Rezoning Application: PD 22-1103
Zoning Hearing Master Date: November 14, 2022
BOCC Land Use Meeting Date: January 10, 2023

1.0 APPLICATION SUMMARY

The applicant is requesting to rezone a 17.4 acre property located at the southeast corner of Cone Grove Road and Fern Hill Drive from Agricultural Rural (AR) to Planned Development (PD) in order to allow for the development of 104 single-family dwellings.

2.4 Proposed Site Plan (partial provided below for size and orientation purposes. See Section 8.0 for full site plan)

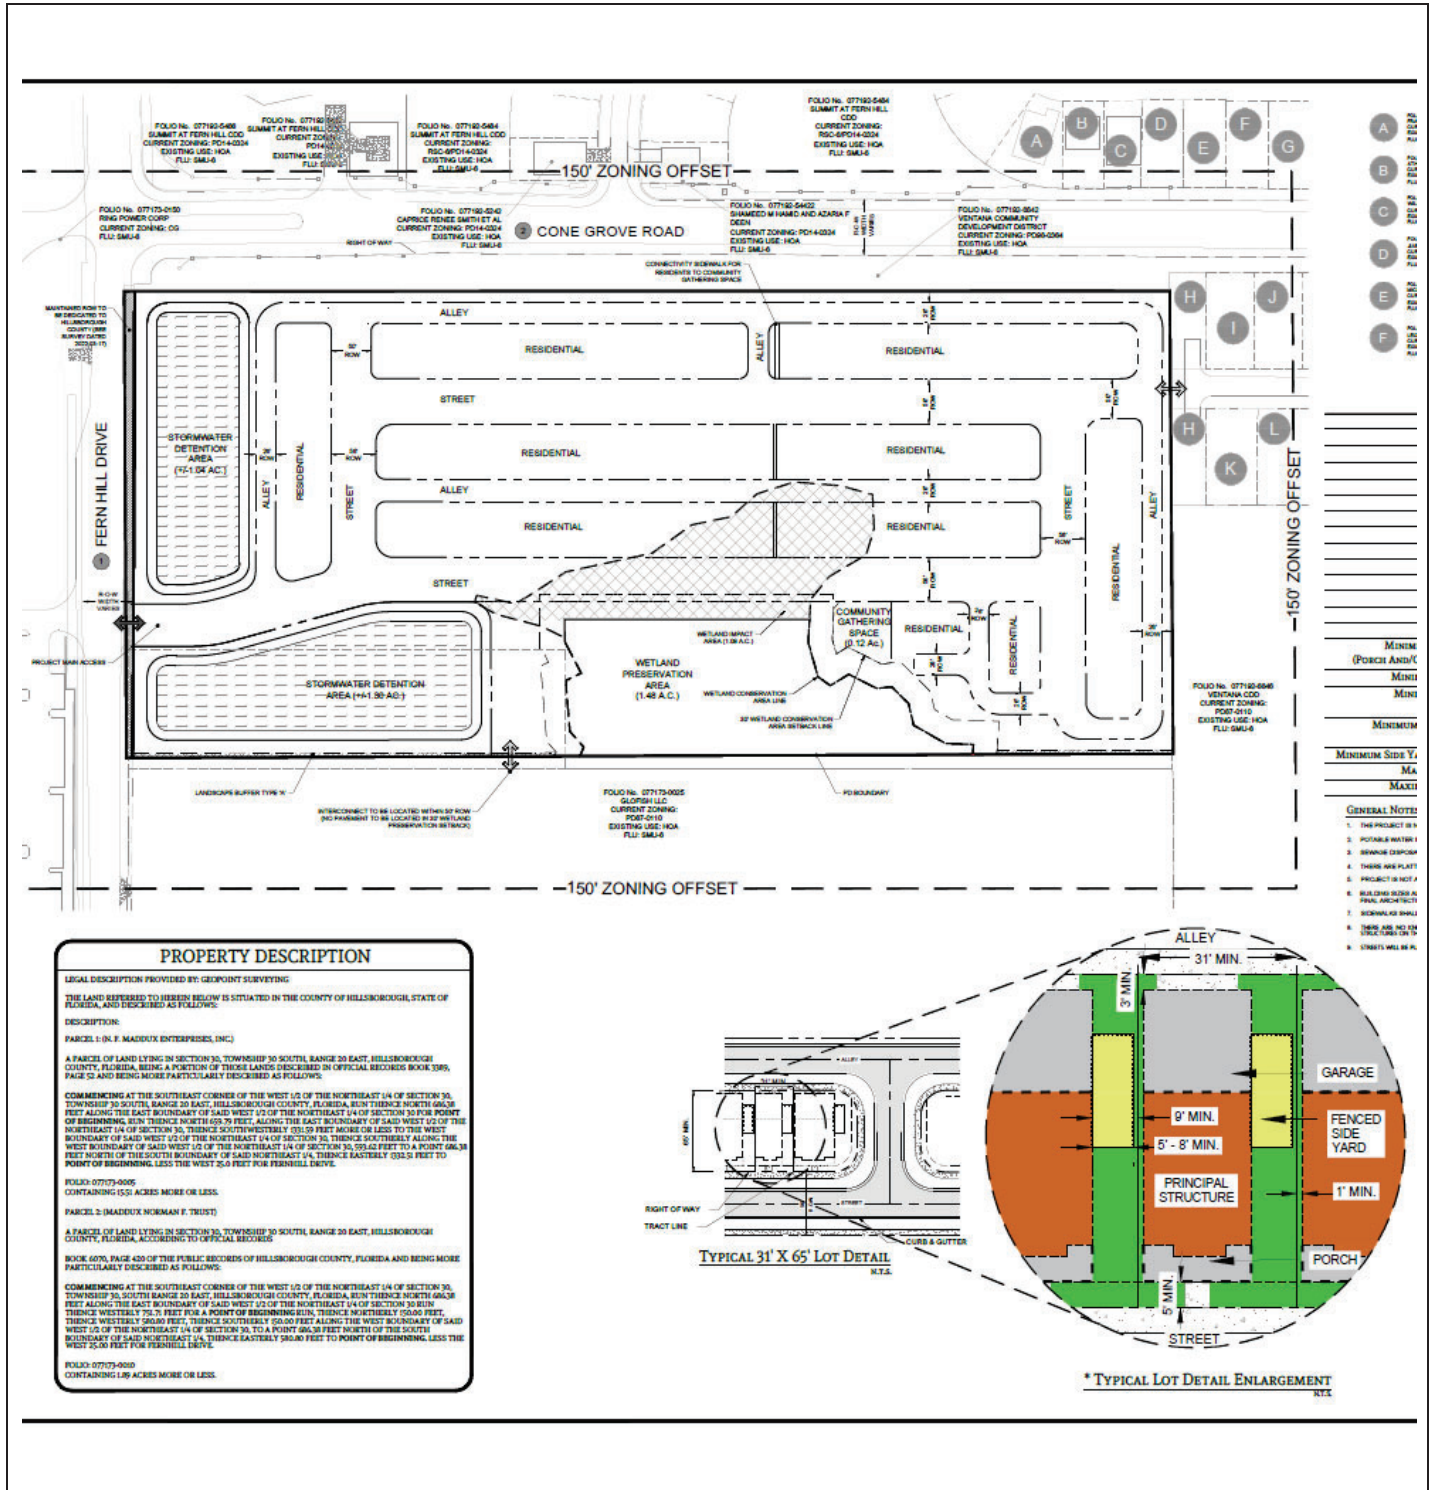
Prior to PD site plan certification, the applicant shall revise the PD site plan to:

1. Add a note on the site plan that reads "Sidewalks to be provided per LDC";
2. Add "Alley" Labels on the site plan to all sections proposed to be built as alleyways; and
3. Revise the Hatched arrow label in the legend to read "Cross Access."

TS-3

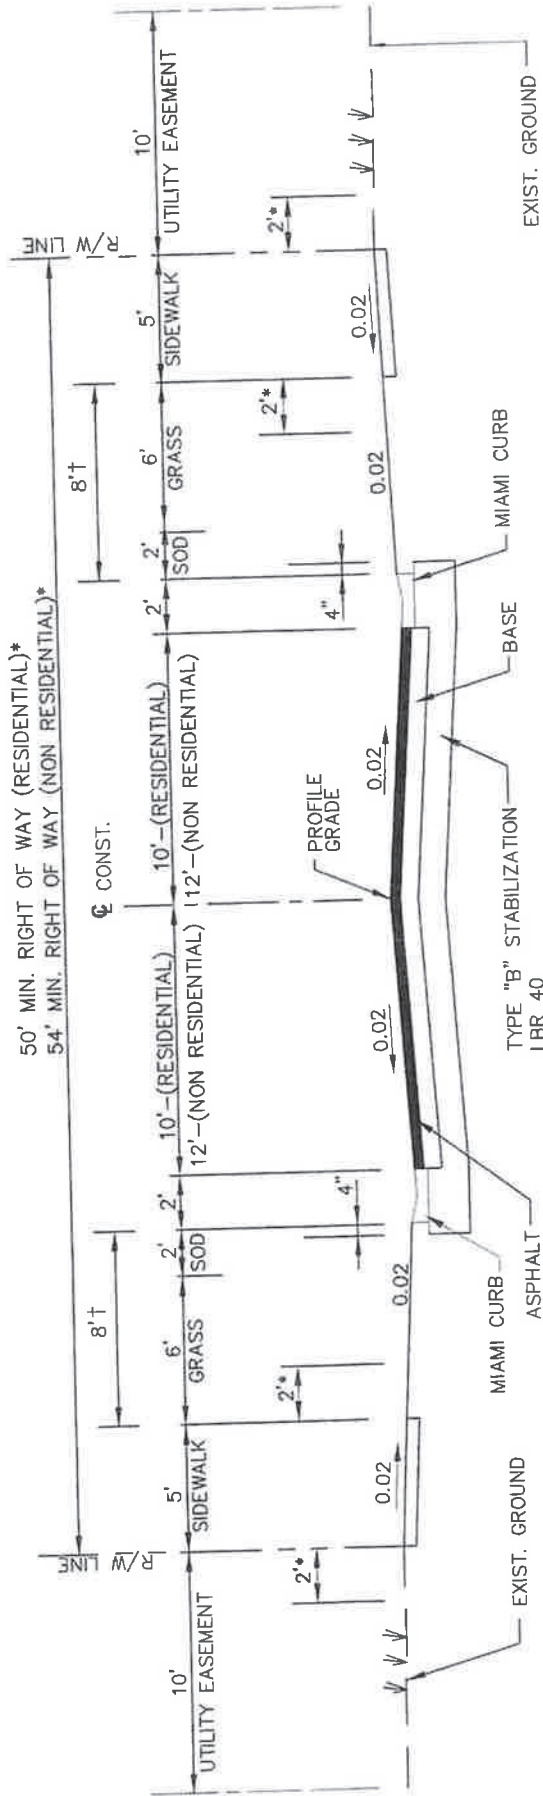
There is limited right of way on the west side of Fern Hill Drive and on the east side south of the subject property. Therefore, it is not feasible to widen the roadway to provide the 7 foot bike lanes. The 4 foot bike lane was the standard at the time of construction of the road that has subsequently been revised. In addition, the development is to construct a 5 foot sidewalk along its project frontage on Fern Hill Drive.

Exhibit B: Proposed 56' R-O-W Section With On-Street Parking

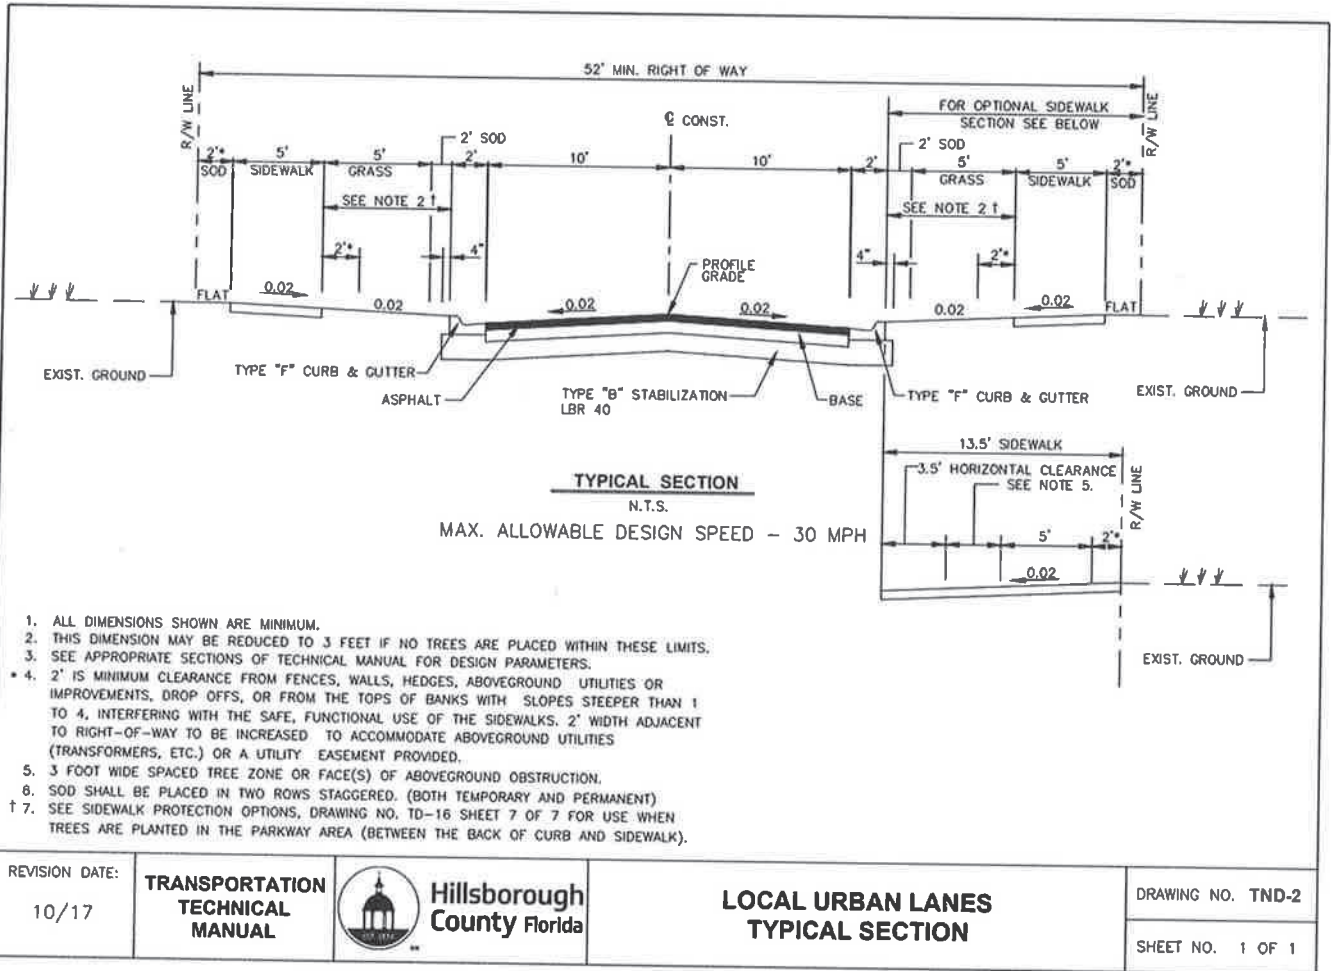
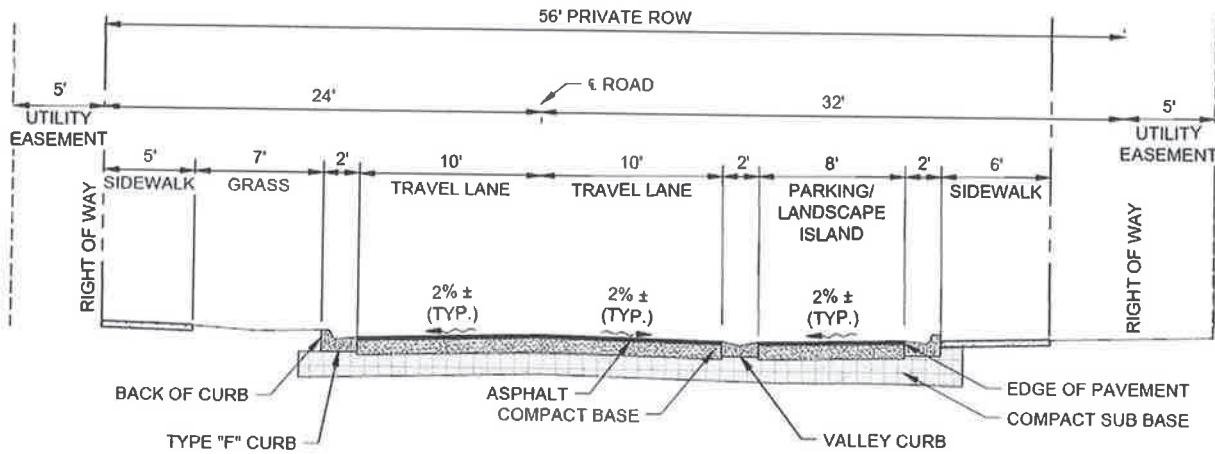
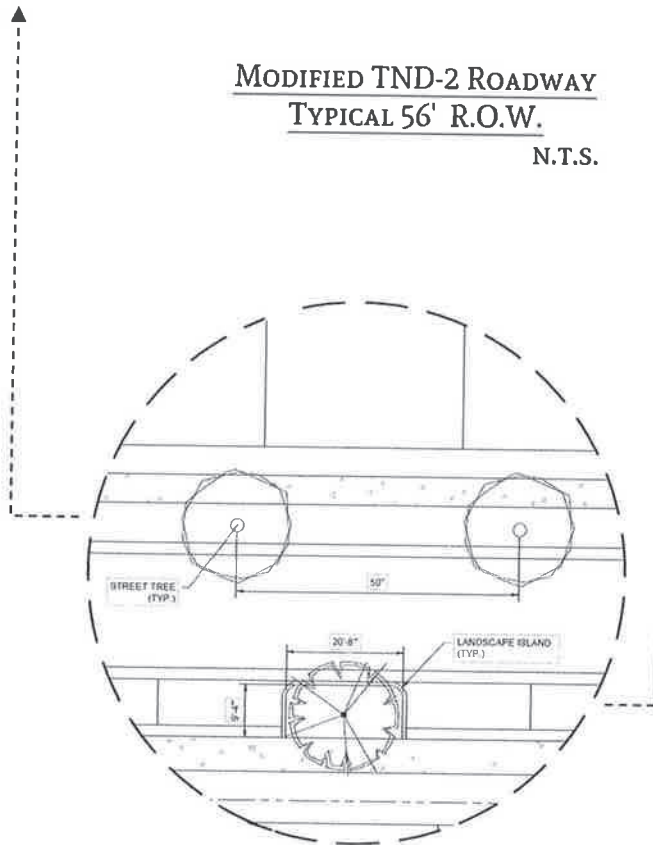
Two possible street sections in the TTM could apply to the design theme of the project, TND-3 (69-foot right-of-way with on-street parking and bike lanes) and TND-2 (52-foot right-of-way). Given the scale and location, the Design Exception is specific to Drawing TND-2, shown as Exhibit A. The request is to increase the typical section from 52 to 56

feet to provide on-street parking on one side. The exception establishes an intermediate section between TND-3 and TND-2. One of the purposes is to create an efficient layout that conforms to the unique setting and minimizes wetland impacts. On-street parking is provided to formalize the location of parking so that residents and visitors are not parking in the travel lanes or obstructing alleys. Street trees are provided on both sides of the street, as depicted in Exhibit B. For the side that includes on-street parking, street trees will be interrupted by no more than three parallel parking spaces. The requested design exception is consistent with the TND theme and fits the location and scale of the community that will have a maximum of 104 homes (see Exhibit C, PD Site Plan).

- The developer shall be permitted to increase the typical section ROW from 52 feet to 56 feet in order to provide on-street parking on one side.
 - The developer shall be permitted to install a 6 foot wide sidewalk on the side of the street that includes on street parking in lieu of the 5-foot wide sidewalk pursuant to TTM TND-2;

Waiver to LDC Section 6.01.04.B.2

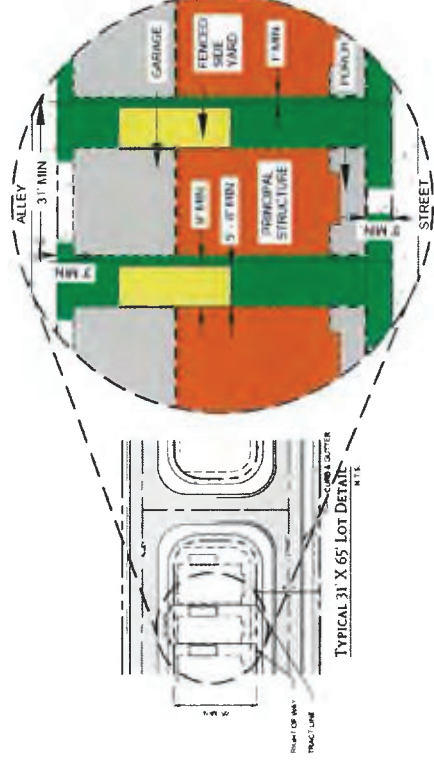
- **Request:** Waive front courtyard requirement for lots with less than 5,600 sq ft.
- **Justification:** Code does not envision TND design with alley loaded garage
- **Staff Finding:** **Approvable** with Conditions (Side Courtyard, 5 ft setback to Stoop or Porch)
